Sequoia Data Center

Docket 19-SPPE-03

Intervenor Sarvey's Reply Testimony

Santa Clara Data Centers Under Commission Review and Distance between SDC and Walsh Avenue DC

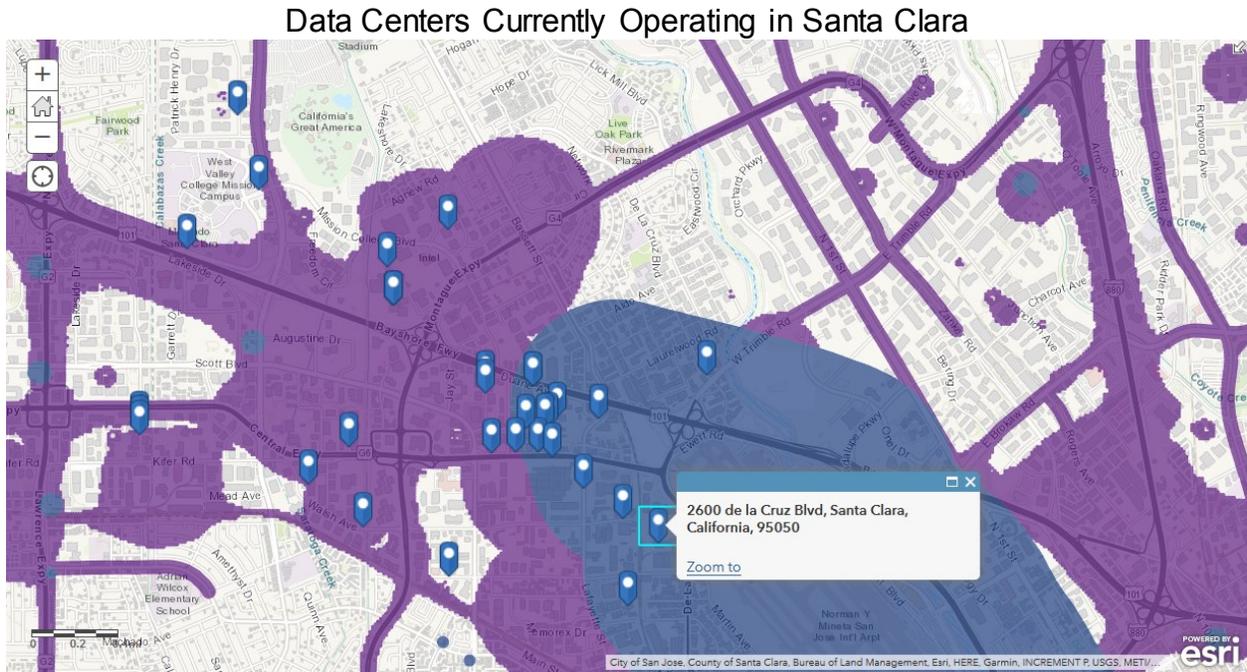
The Energy Commission is currently processing six data centers in addition to the McLaren Data Center and Laurelwood Data Center which were recently approved. One of the data centers the 651 Walsh Avenue Data Center currently under Energy Commission review is less than 1,000 feet from the SDC as depicted in the map below.

BAAQMD has determined that the project area shaded in blue in the map above requires further study. BAAQMD Planning Healthy Places handbook on page 12 describes the blue shaded project area in the map above. The handbook states,

Data Centers recently approved by the City of Santa Clara

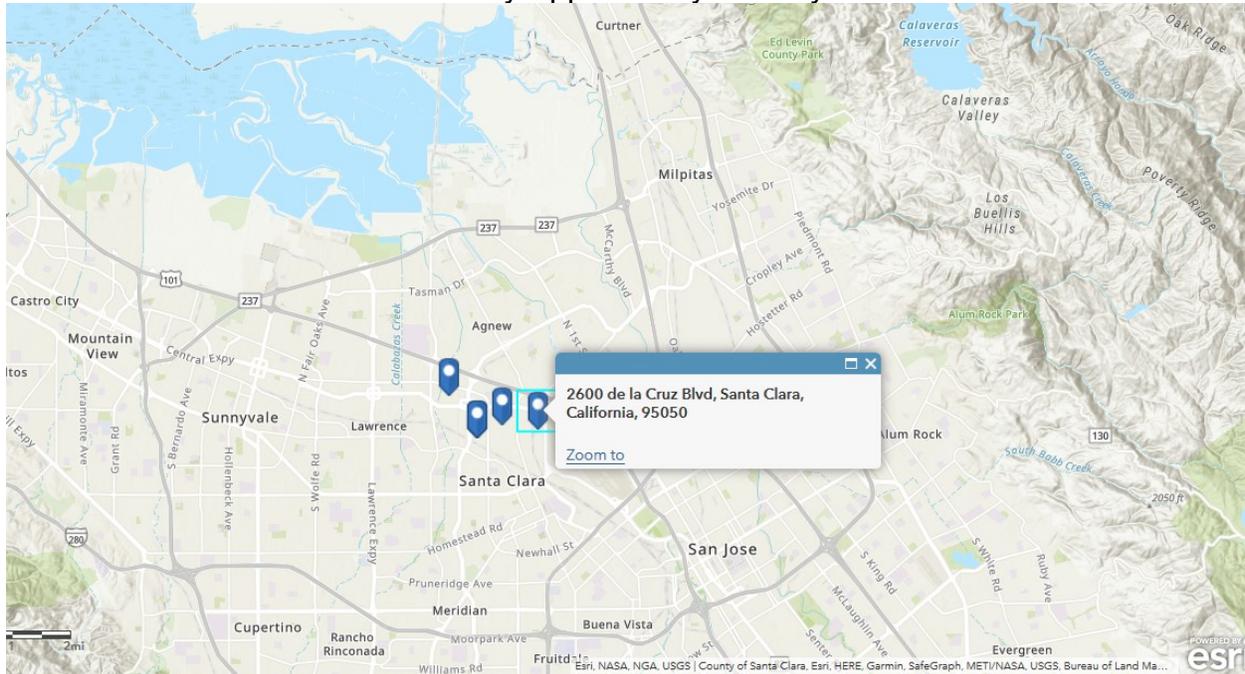
generating capacity of 30 MW.<sup>58</sup> The project is estimated to emit 32,569 metric tons of CO<sub>2</sub>e per year. The emergency generators are estimated to emit 823 metric tons per year from generator testing.<sup>59</sup> Testing of the projects generators is estimated to produce 12.9 tons per year of NO<sub>x</sub> and .3 tons of diesel particulate matter.<sup>60</sup> The data centers are located on the map below.

As can be seen the project area is overburdened with pollution before the many new data centers spew their diesel particulate and NO<sub>x</sub> emissions. A fair argument has been made above that a cumulative impact assessment is required for this project due to the existing and future data centers. Accordingly the Energy Commission must require preparation of a complete Environmental Impact Report to be compliant with CEQA.
